TEMPORARY REVISION

TR-MÄM-20-405

Change from CHT to Coolant Temperature Measurement

This Temporary Revision TR-MÄM-20-405 is approved in conjunction with the Mandatory Design Change Advisory MÄM 20-405 and is valid in conjunction with the latest revision of the DV 20 Airplane Flight Manual until this Temporary Revision has been incorporated into the Airplane Flight Manual.

6.5. EQUIPMENT LIST

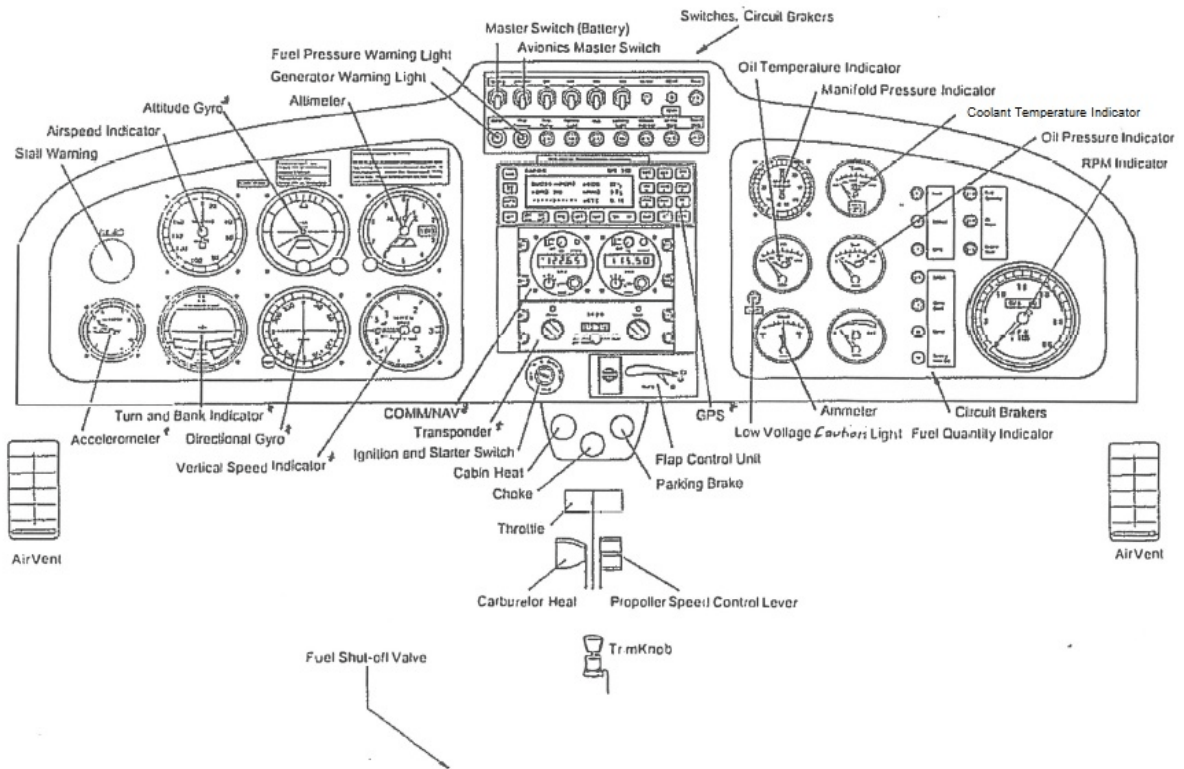
Item I 6 is amended to read:

Seq. No.:	Part Description, Manufacturer, Type	Serial No.:	Inst.	Mass [kg] (lbs)	Arm [m] (in)
I 6	if MÄM 20-405 is installed: Coolant Temperature Indicator TC1-9031-10-01_01			0.14 (0.31)	-0.390 (-15.35)
	if MÄM 20-405 is NOT installed: Cylinder Head Temperature Indicator HOAC 16160			0.14 (0.31)	-0.390 (-15.35)

7.11. ELECTRICAL SYSTEMS

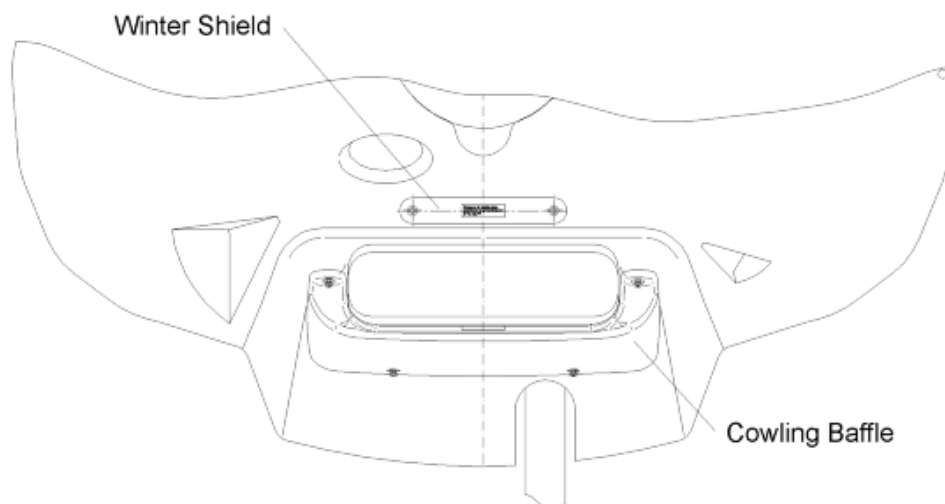
The following paragraph is added:

if MÄM 20-405 is installed:

The instruments for temperature, oil pressure, and fuel quantity are connected in series with the respective sensors. The electrical resistance of a sensor changes with the measurable variable, which causes the power to the instrument and consequently the needle deflection to change. Oil pressure indicator, coolant temperature indicator and fuel pressure warning light are supplied with power through one circuit breaker. Oil temperature indicator and fuel quantity indicator are also protected together by one circuit breaker.
